FDOT FY 2016-17
 DESIGN STANDARDS

UNDERDRAIN INSPECTION BOX

INDEX NO.
 245

TYPICAL TOP AND APRON

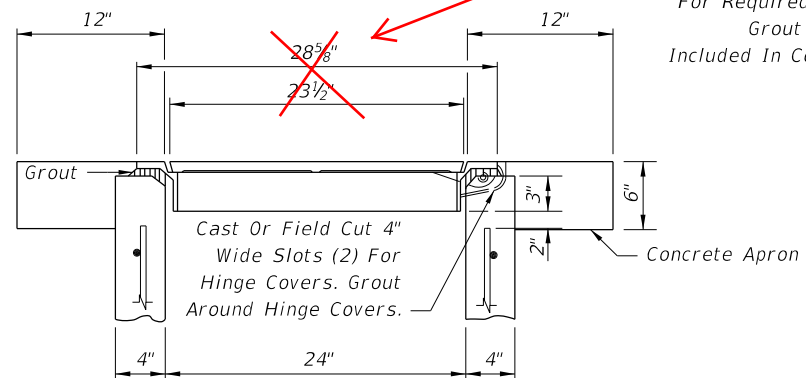
Corrected Dimensions:
~~28 5/8"~~
~~23 1/2"~~
28 1/2" or 28 3/4"
and
23 1/2" or 21 1/2"
